MONITORING YEAR 1 ANNUAL REPORT

HONEY MILL MITIGATION SITE

RE: Draft Year 1 Monitoring Report
Honey Mill Mitigation Site, Surry County
Yadkin River CU 03040101
DMS Project ID No. 100083 / DEQ Contract #007619

Wildlands Engineering, Inc. (Wildlands) has reviewed the Division of Mitigation Services (DMS) comments from the Draft Year 1 Monitoring Report for the Honey Mill Mitigation Site that were received on January 31, 2022. The report has been updated to reflect those comments. The Final MY1 Report is included. DMS' comments are listed below in **bold**. Wildlands' responses to DMS' comments are noted in *italics*.

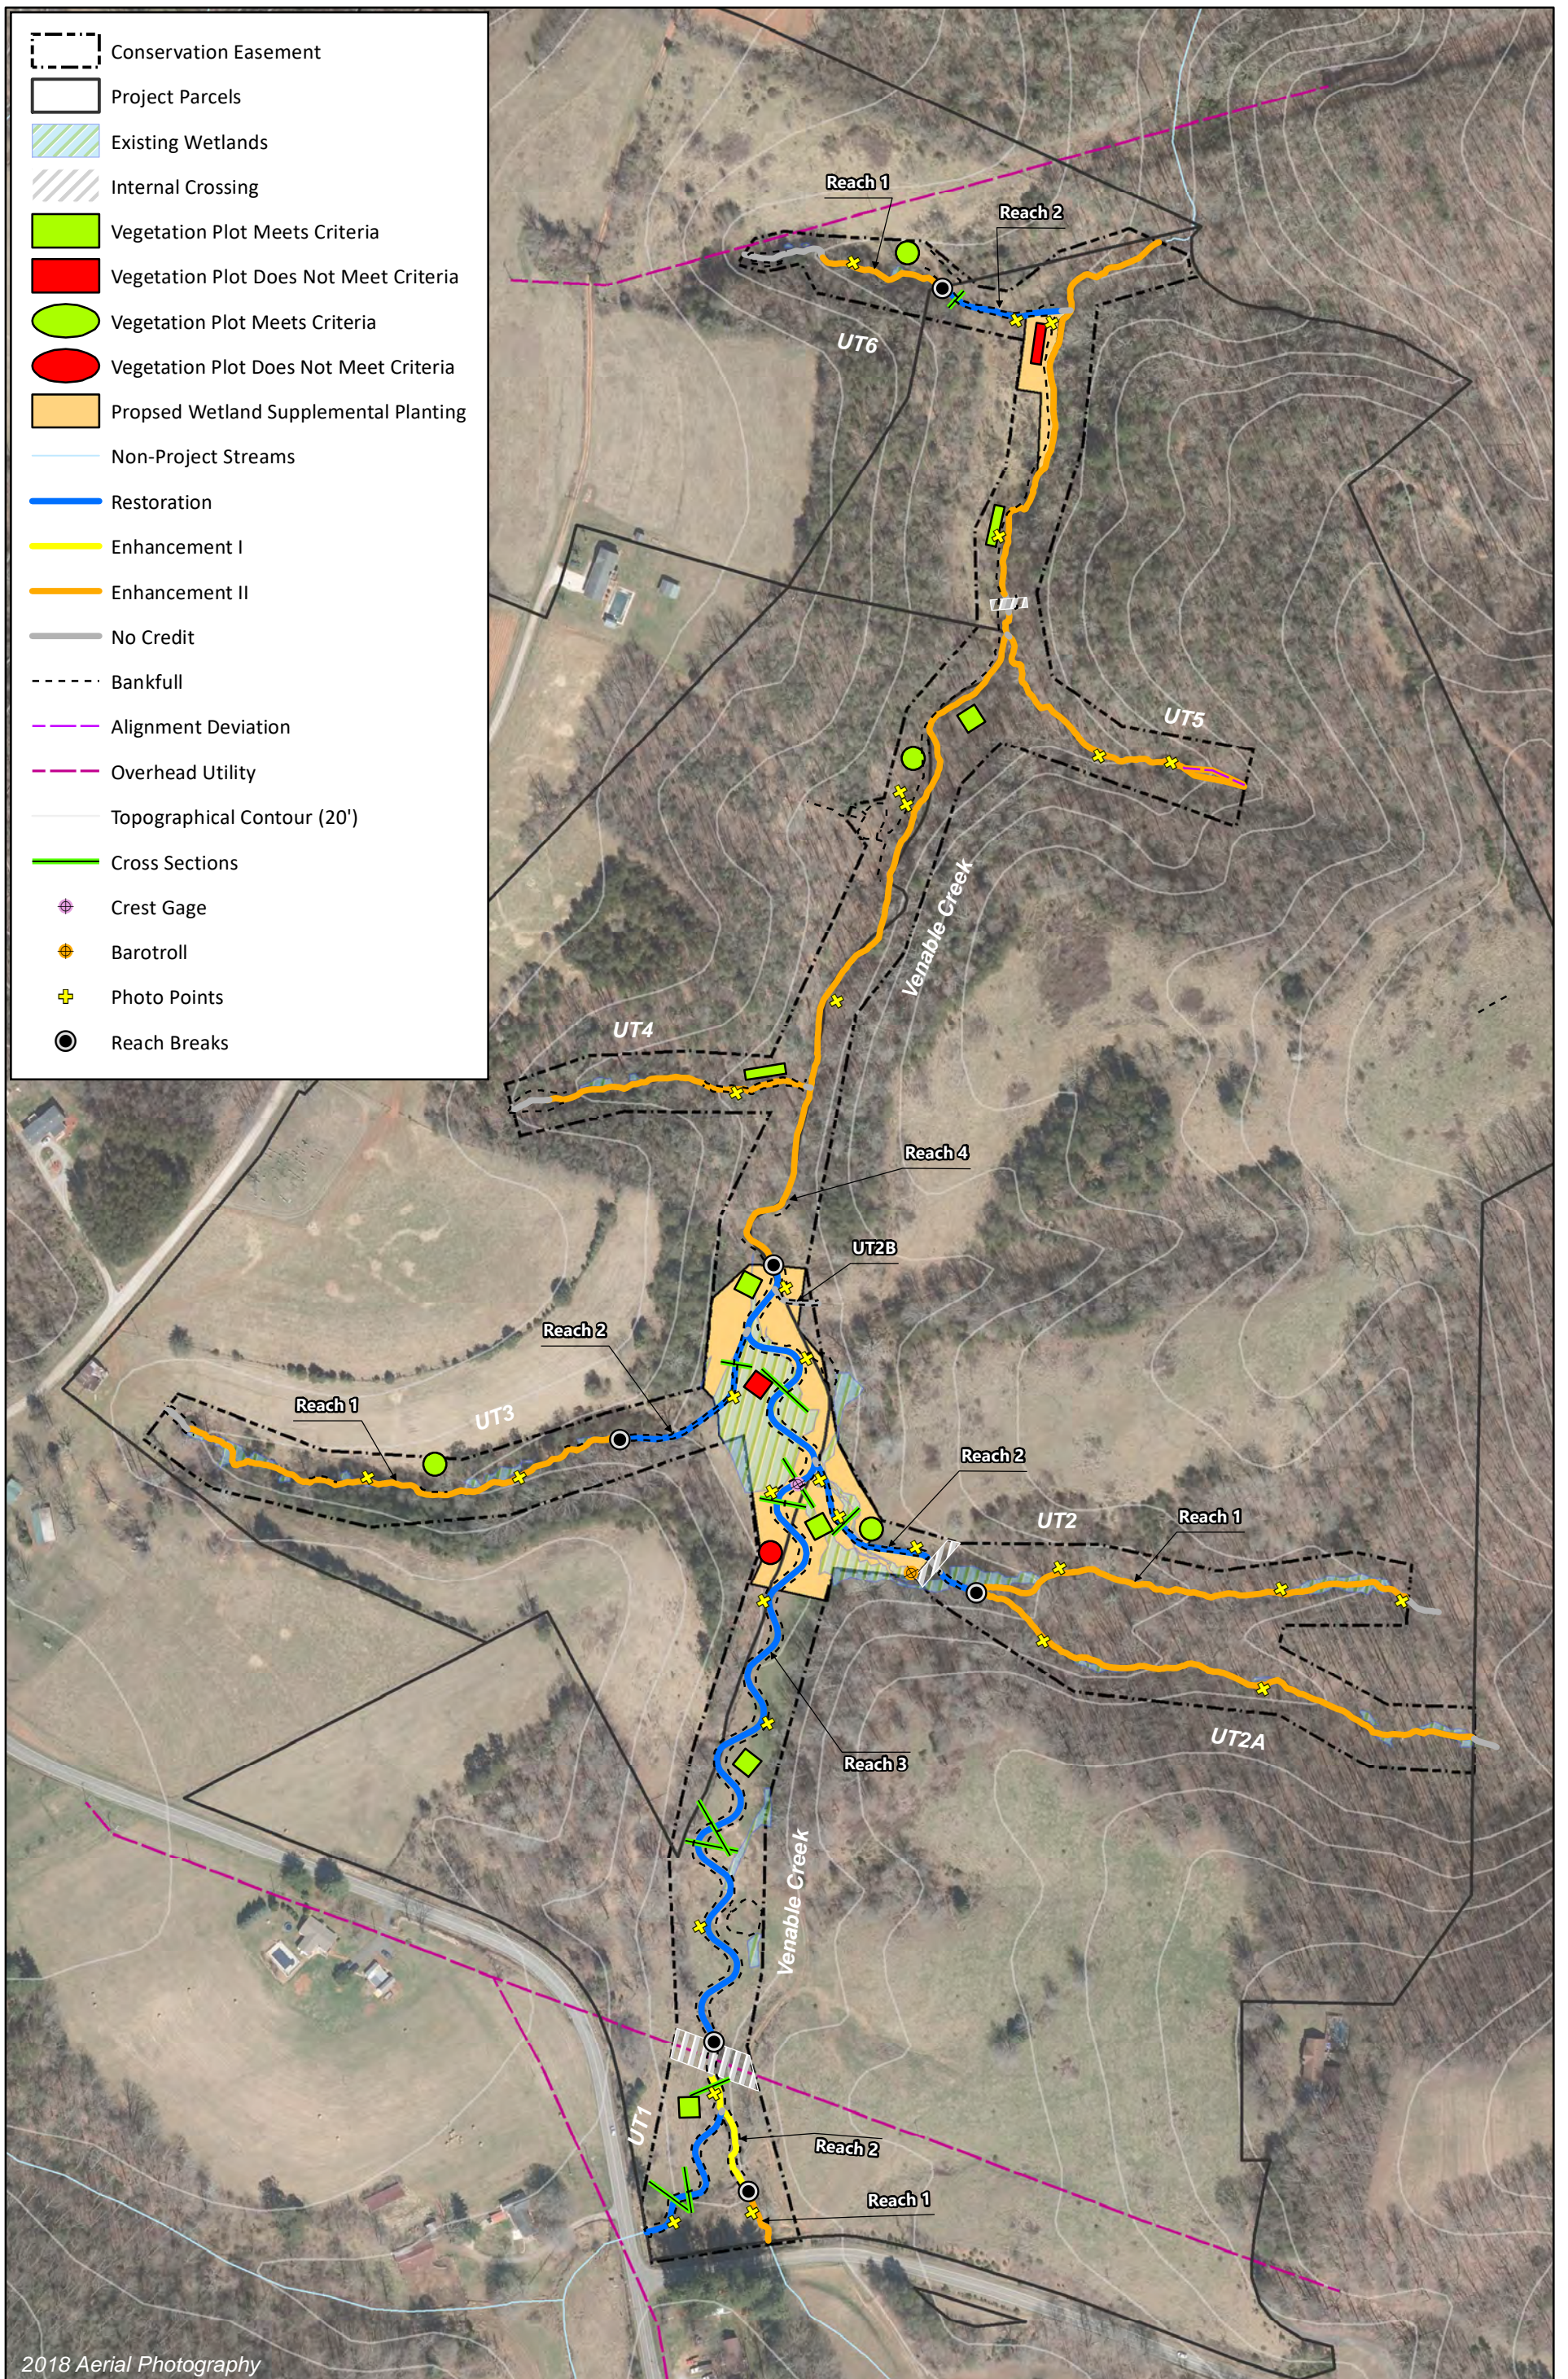
DMS' comment: Please reference the January 3rd approval for the 2.5 acres of proposed replanting in the executive summary. Consider adding an adaptive management section to the report to detail any additional efforts required to assess any concerns specific to this issue beyond routine stem counts. Will supplemental evaluation be conducted to validate the success of the replanted areas of are soil samples being submitted for laboratory analysis?

Wildlands' response: The date of approval has been added to the executive summary.

As stated in the MY1 report for Honey Mill's Mitigation Site, the 2.5 acres of supplemental planting will be conducted only within in wetland areas and/or areas of the floodplain which are trending much wetter than previously anticipated. The Site's planting list for implementation after construction did not contain a good mix of bareroot species tolerant to wet or saturated soil conditions, especially facultative species with a wetland indicator status of FACW or OBL. The determination for our proactive approach to supplementally plant with species more conducive to wetland and wetland type conditions was to address a planting oversight for the proposed areas, prevent potential stem mortality, and keep vegetation densities and vigor within the floodplain thriving. Therefore, Wildlands used professional judgement to determine the necessary course of action, rather than developing an adaptive management plan for replanting an area under the minimum replanting threshold or conducting laboratory soil analysis. Neither of which would likely provide any additional, necessary information than what was presented in the MY1 report.

Wildlands is not planning to provide any supplemental evaluation of the replanting areas. Currently, Wildlands conducts site-wide reviews of the project area, as well as vegetation plot monitoring throughout the open planted areas. With 5 permanent vegetation plots located within the replanted areas and 4 mobile plots that will be relocated throughout the open planted areas within the riparian corridor, the replanted areas will be sufficiently monitored. Additionally, when the NC IRT approved our

Honey Mill Mitigation Site Record Drawings
 Surry County, North Carolina

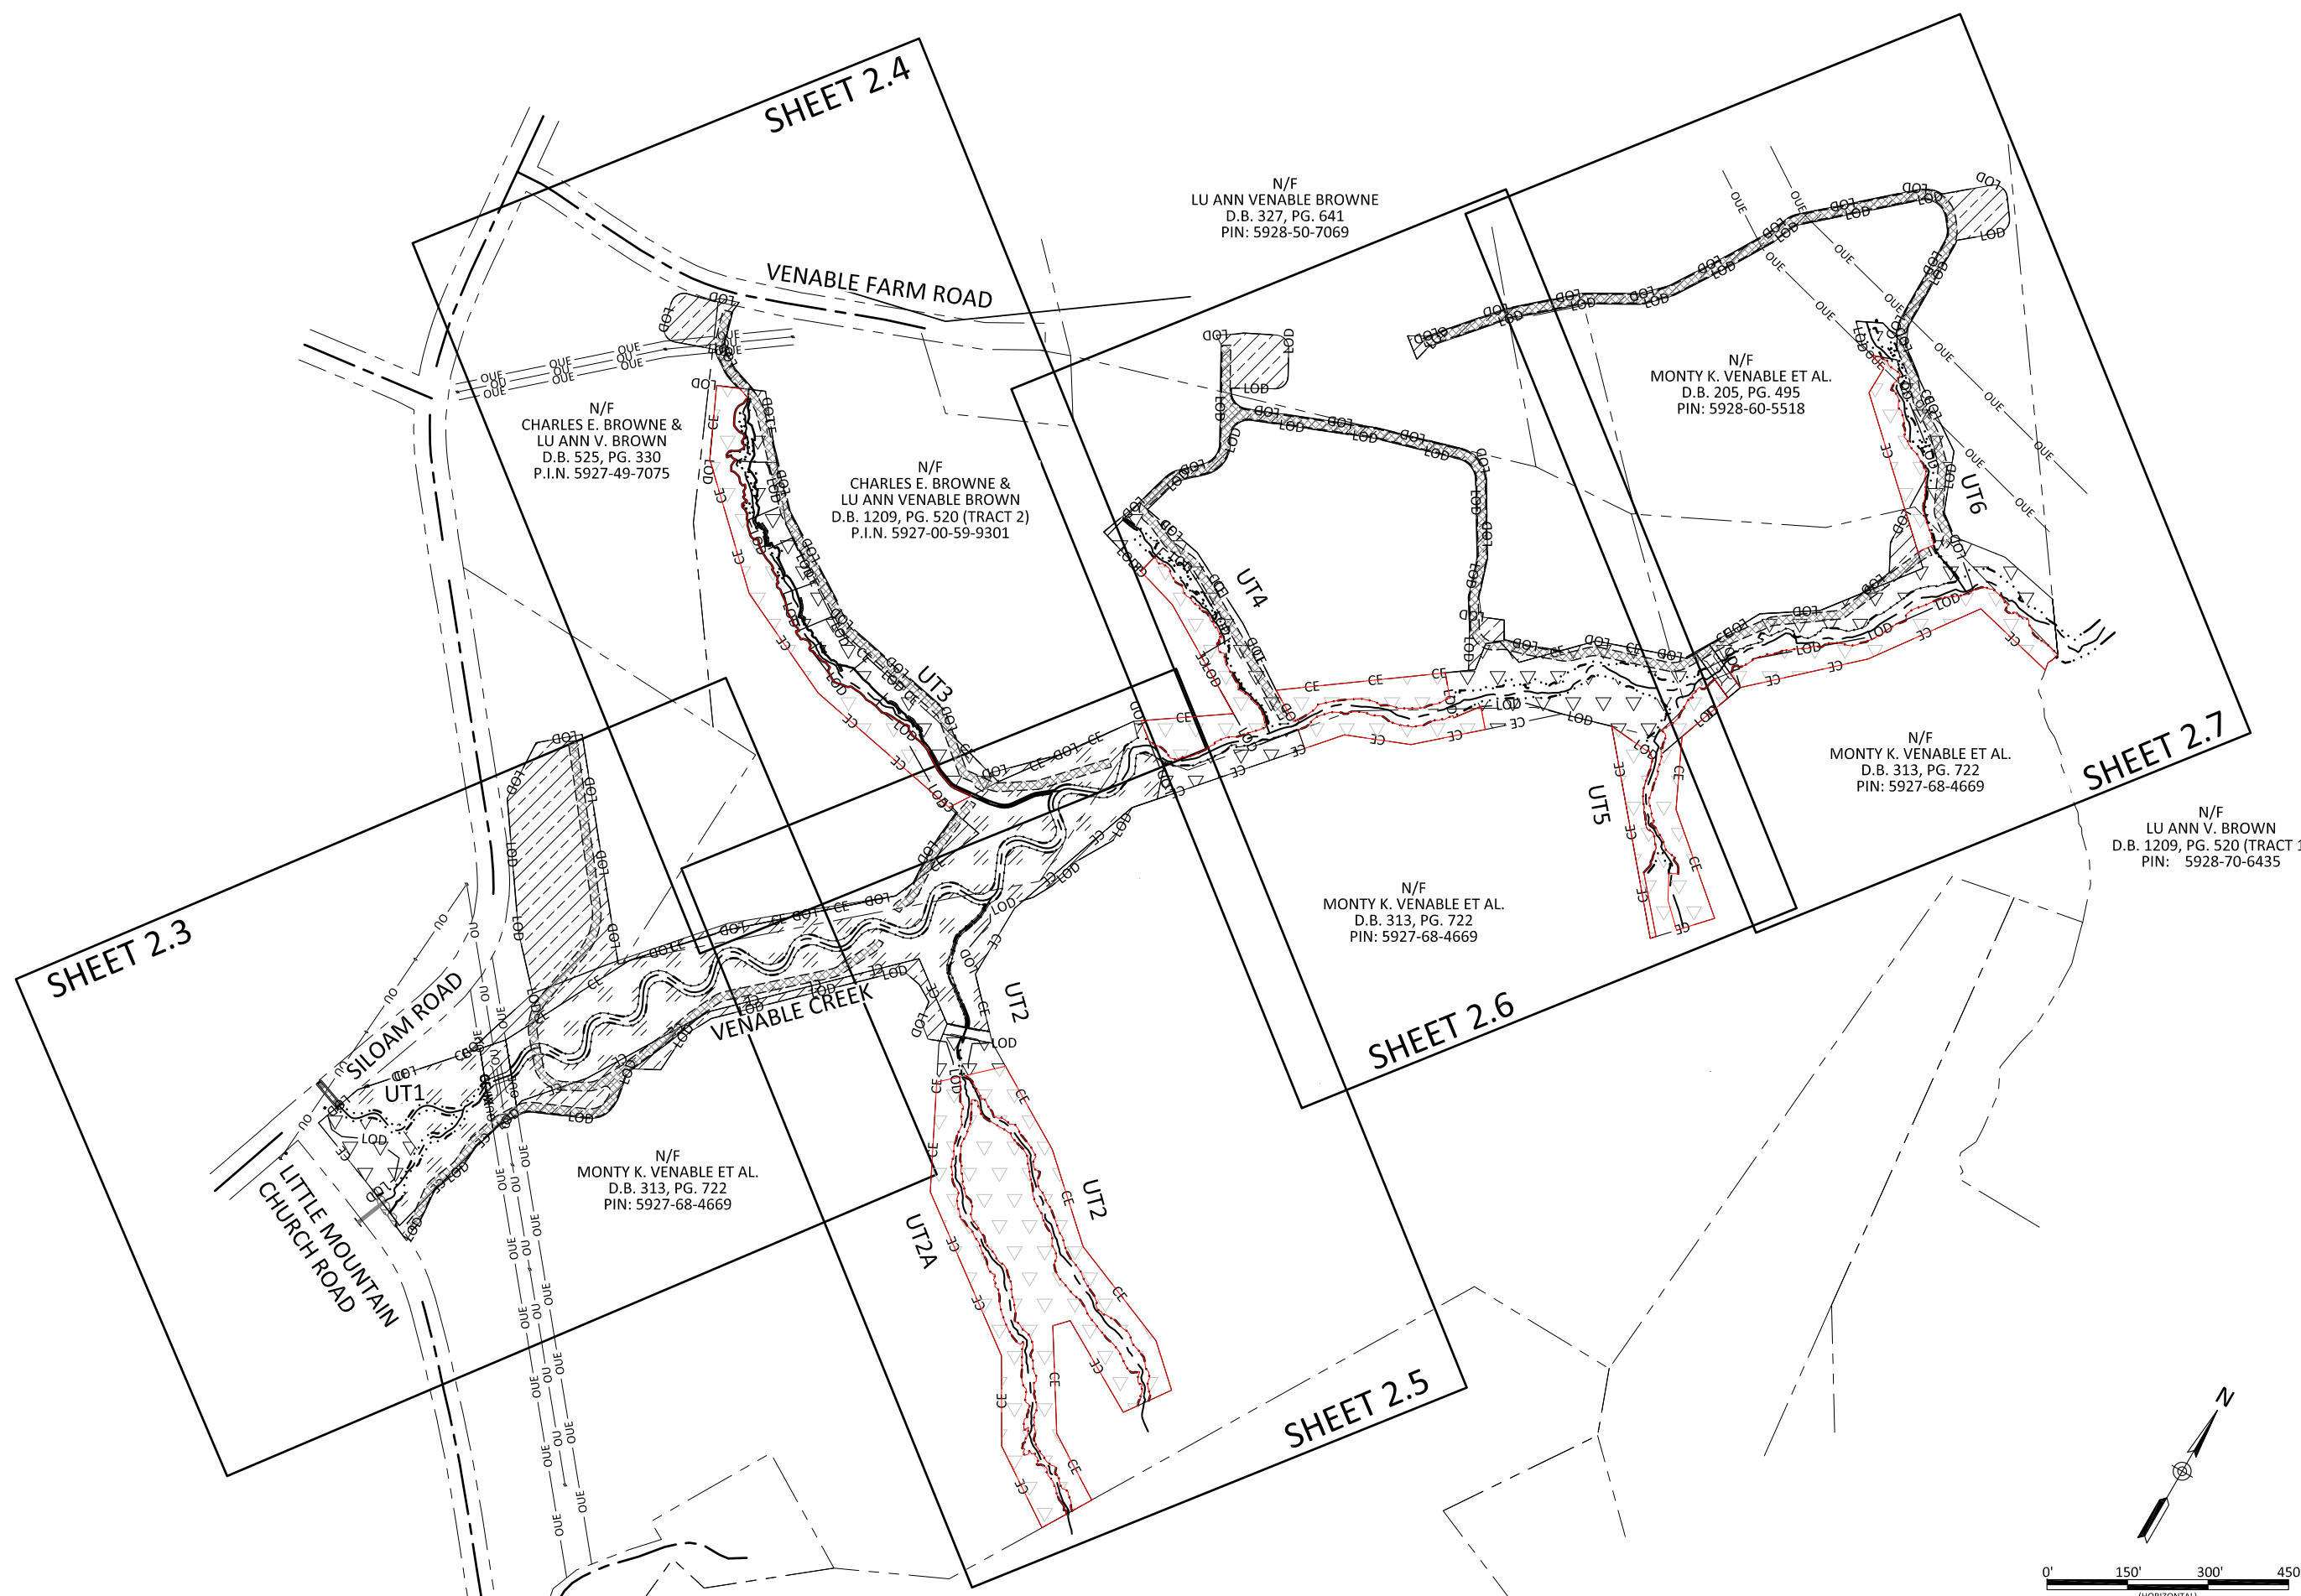
1. *I noted all (very few) redline changes in the plan diagrams and concur with all changes. My only comment is that structures update in red for the plan views should also appear in the stream profile to help illustrate differences in the planned or designed grade and the actual grade of either the thalweg or banks.*

WILDLANDS RESPONSE: Wildlands does not normally show structure invert elevations or structure type deviations on the record drawing profile. We do show significant changes in the profile as red in the record drawings. Since the structures were installed within acceptable tolerances, no elevation deviations were shown on the profile.
